REMARKS

This Preliminary Amendment is to clarify portions of the Application, including the Specification and Claims, to add a new claim, to add a replacement Abstract of the Disclosure, and to amend the Drawing. Also included are a Substitute Specification, a marked-up copy of the Substitute Specification showing the changes made and an English-translation of the International Application. No new matter has been added.

**MARKED-UP COPY**  
**OF SUBSTITUTE SPECIFICATION**

~~CENTRIFUGE COMPRISING A SEPARATOR DISC STACK AND SEPARATOR DISC~~

~~Fig. 1~~

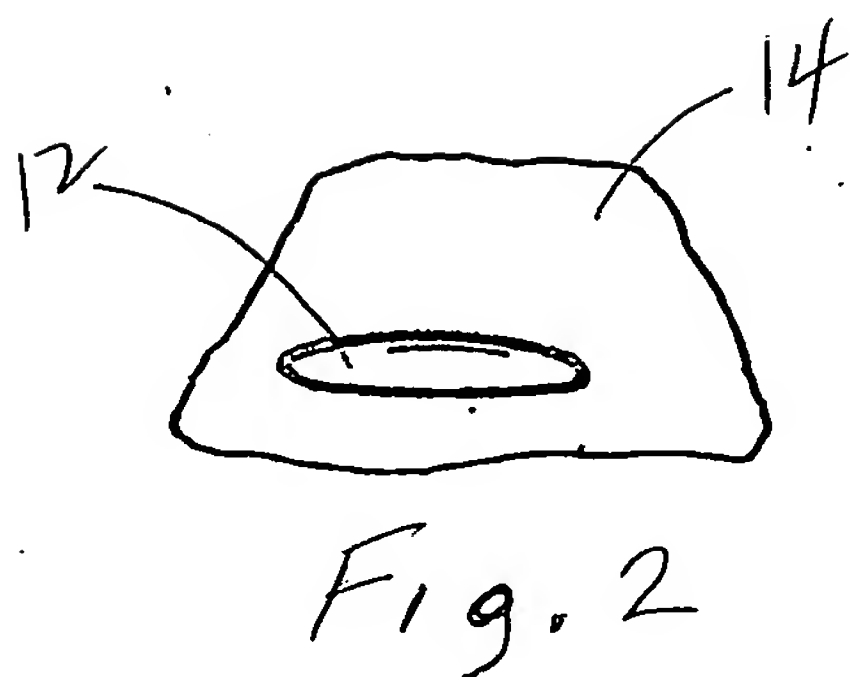
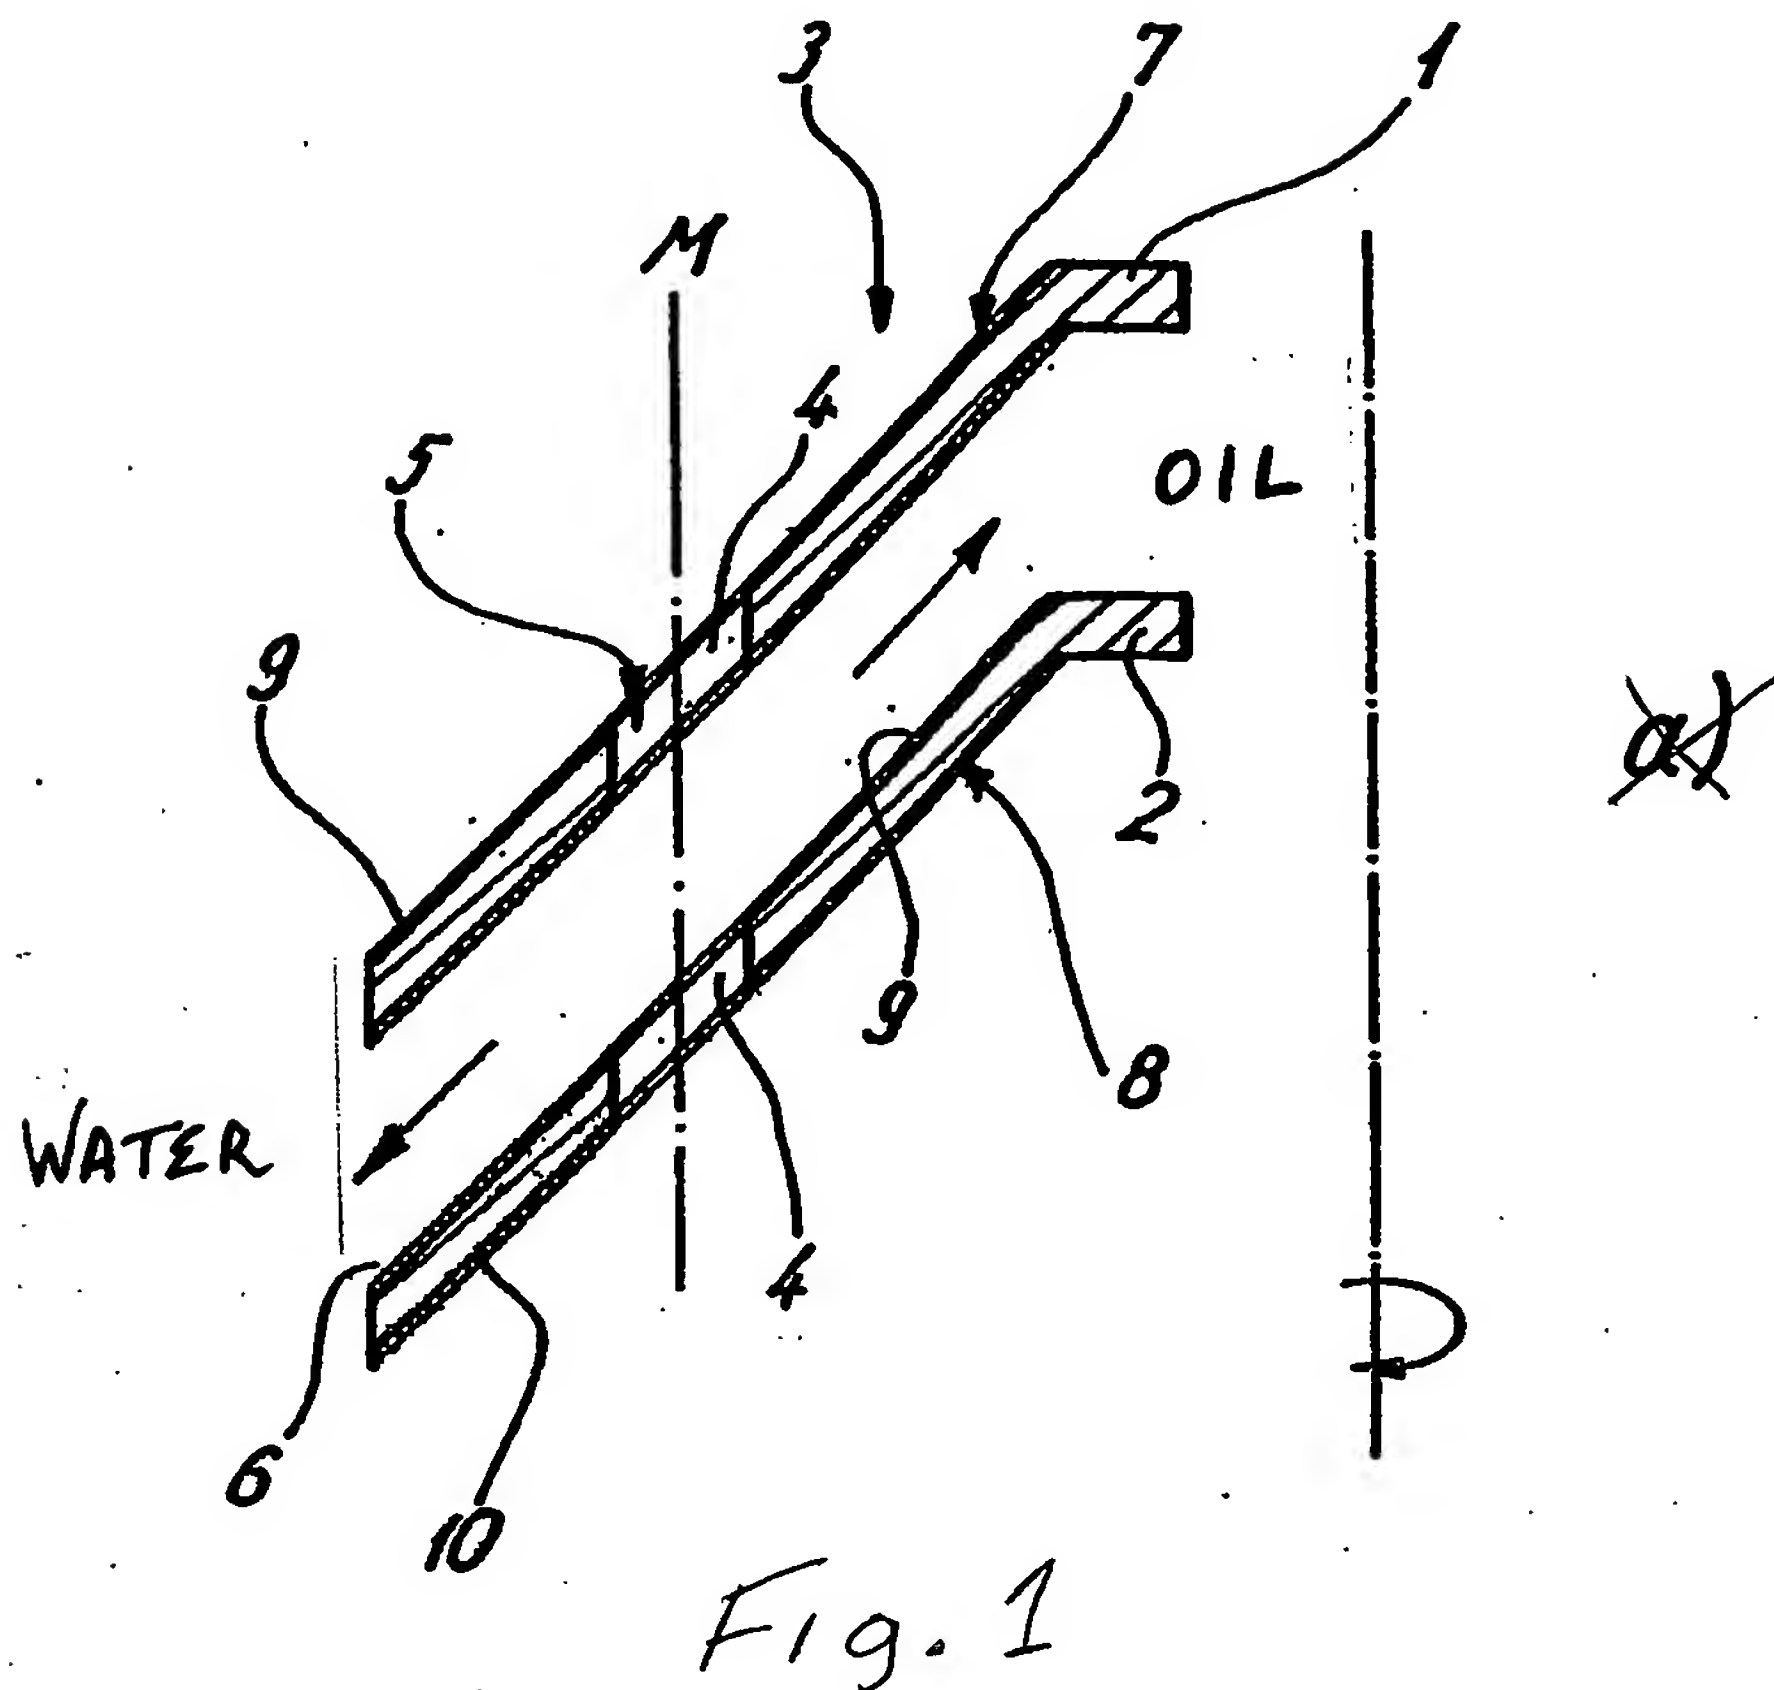
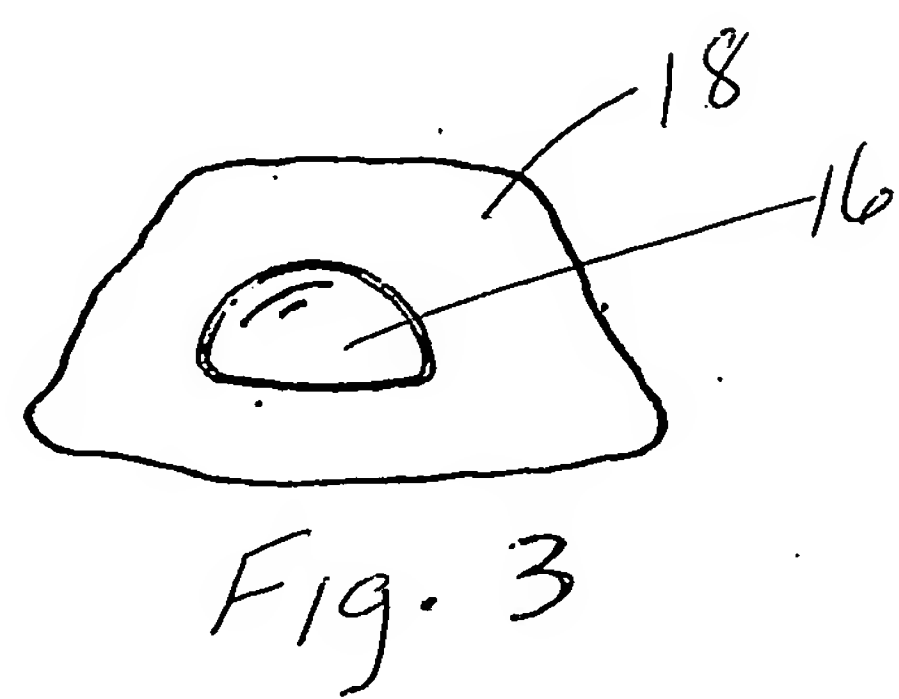
Please note the enclosed drawing sheet marked as “Annotated Sheet”.

Please enter the enclosed drawing sheet marked as “Replacement Sheet”.

**[00017]** ~~Figure 1a, b is a schematic representation of the a method of operation of a separator disc—discs according to the present disclosure, and invention and a representation of the principle of the invention in comparison to the separator disc according to the state of the art on the an example of a coating on the separator disc. This figures Figure 1 should only be understood to be strictly an example of a treatment. Instead of being generated by means of surface coatings, the areas of other a changing of surface energy~~

[00018] Figure 2 shows a representation of an uncoated portion of a separator disc,  
including a water drop.

[00019] Figure 3 shows a representation of a coated separator disc, according to the present  
disclosure, and including a water drop.

29][00030]\_\_\_\_\_In the left hand drawing, Figure 1b 2 shows the a flattened shape of a wider water drop 12 on an uncoated separator disc, and the right hand drawing 14. Figure 3 shows a corresponding water drop 16 on a correspondingly coated separator disc 18. which water drop 16 is narrower and clearly not as wide as the water drop 12 in Figure 2. Water drop 16 is higher but has the same volume, which is promoted by the correspondingly a selected coating of the separator disc 18. The following should be is noted here concerning the theory of coatings. In addition to the surface structure, the surface energy is a criterion for adhesions. The treatment of the separator discs by polishing changes the surface energy only slightly but does not generate a so-called non-stick layer. A reduction of adhesions can be explained by the an implemented change of the structure. The surface energy of the separator discs 1, 2 is situated in an area of an adhesive layer and is water-friendly (separator; for example, water/oil).
